KUNDRATHUR TOWN PANCHAYAT

SKETCH SHOWING THE SUB DIVISION OF PUBLIC PURPOSE PLOT NO.VII INTO RESIDENTIAL USE IN THE APPROVED LAYOUT P.P.D/L.O.NO.15/2017 IN S.Nos. 469/1pt, 470pt AND S.No.477/2pt OF KUNDRATHUR VILLAGE.

P.P.D	NO	70 ✓
L.O		2018
APPROVED		
VIDE LETTER NO	:	L1/15270/2018
DATED	:	/ 11 / 2018

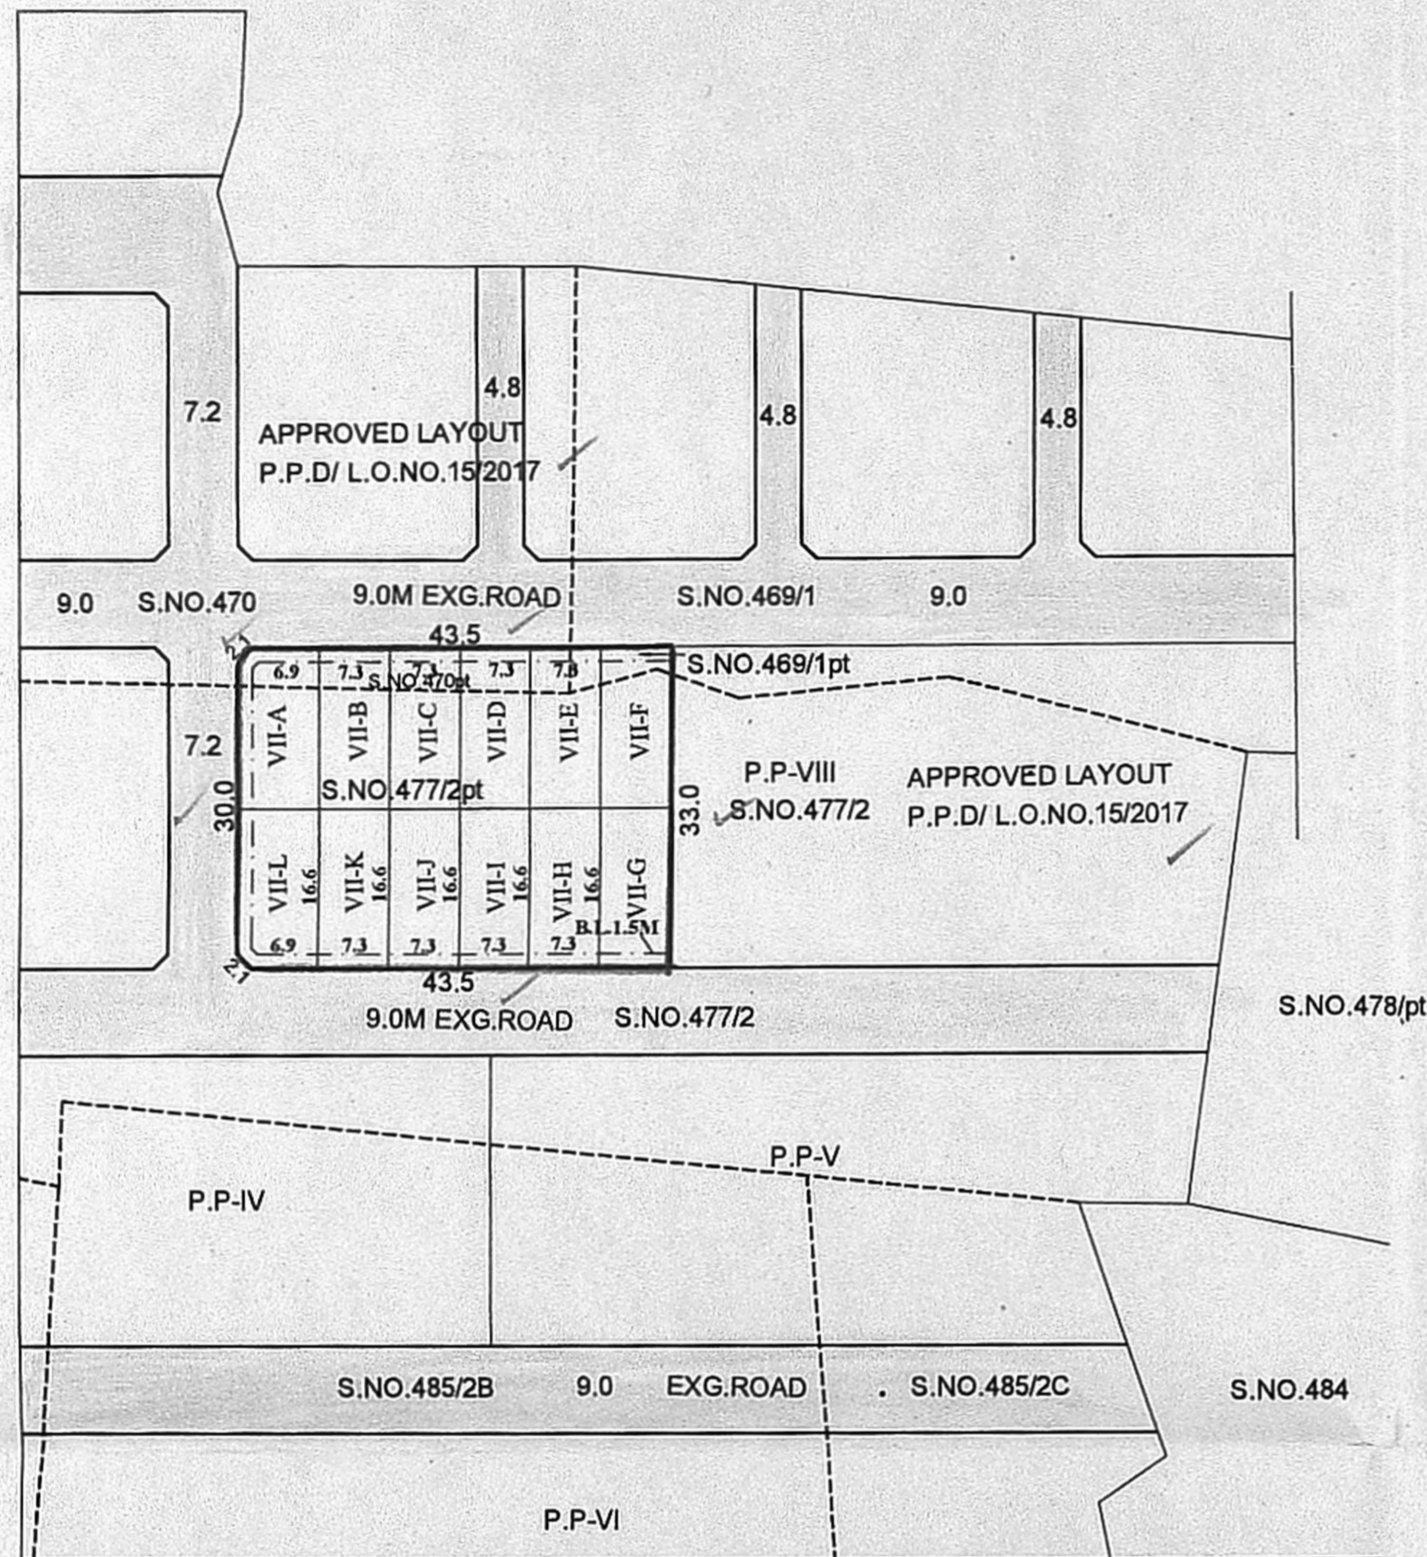
1. THE PROCESS OF EARTH FILLING AND COMPACTION SHOULD BE DONE FOR A DEPTH VARYING FROM 1.520 M TO 3.390 M DEPENDING UPON THE EXISTING FIELD LEVELS IN LAYERS OF NOT MORE THAN 0.30 METRE DEPTH TO ACHIEVE REQUIRED DEGREE OF COMPACTION AND THE EXISTING APPLICANT LAND SHOULD BE RAISED TO A LEVEL OF (+) 19.290M AND THE FILED UP TOP SURFACE SHOULD HAVE A GENTLE FALLING GRADIENT TOWARDS THE EAST/SOUTH DIRECTION.

2. THE ALL-ROUND PAVEMENT LEVEL WITHIN SITE SHOULD BE AT (+) 19.290M. THE APPLICANT SHOULD PROVIDE ALL-ROUND AND INTERIOR STORM WATER DRAINAGE NETWORK, SO THAT THE ULTIMATE DISPOSAL OF STORM WATER SHOULD BE DISCHARGED TO BE NEAREST NATURAL STORM WATER CHANNEL/DRAINS EXISTING ON THE EASTERN AND SOUTHERN SIDE OF THE APPLICANTS LANDS. THE APPLICANT SHOULD MAKE DRAIN NETWORKS AT THEIR OWN COST AND THE SAME IS TO BE CONNECTED TO THE NATURAL STORM WATER DRAINAGE OR CHANNEL. ALSO THE APPLICANT SHOULD PROVIDE EMERGENCY PUMPING OPERATION FOR THE SEEPAGE WATER IF IT IS PROPOSED TO HAVE BASEMENT FLOOR.

8. THE APPLICANT SHOULD PROVIDE A PUCCA COMPOUND WALL ALL-ROUND THE PROPOSED LAYOUT SITE AND A SETBACK DISTANCE OF ABOUT 3.0M SHOULD BE LEFT WHEREVER THE SITE ABUTTING THE CHANNEL.

9. THE APPLICANT SHOULD CLEARLY DEMARCATHE THE BOUNDARY OF THEIR LAND BEFORE THE COMMENCEMENT OF ANY DEVELOPMENTAL ACTIVITIES AND SHOULD NOT ENCROACH THE CHANNEL ABUTTING THE LAND.

10. THE APPLICANT SHOULD PROVIDE NECESSARY ARRANGEMENTS FOR FREE FLOW OF WATER THROUGH THE EXISTING CHANNEL TO THE DOWN SIDE AREA WITHIN THE PROPOSED LAYOUT SITE. ALSO THE APPLICANT SHOULD DESILT THE CHANNEL PERIODICALLY AND REMOVE THE OBSTRUCTION THEN AND THERE WITHOUT ANY HINDRANCE FOR FREE FLOW OF WATER AT THEIR OWN COST WITHIN THE PROPOSED LAND AND CONDITION NO.5 STIPULATED FOR CULVERT PERMISSION FURNISHED BELOW.

11. THE APPLICANT SHOULD NOT CARRY OUT ANY OTHER CROSS MASONRY STRUCTURES ACROSS THE CHANNEL WITHOUT PRIOR PERMISSION FROM PWD.
12. THE PWD/WRD OFFICIALS SHOULD BE ALLOWED TO INSPECT THE SITE AT ANY TIME DURING EXECUTION AND AFTER COMPLETION OF PROJECT ALSO.
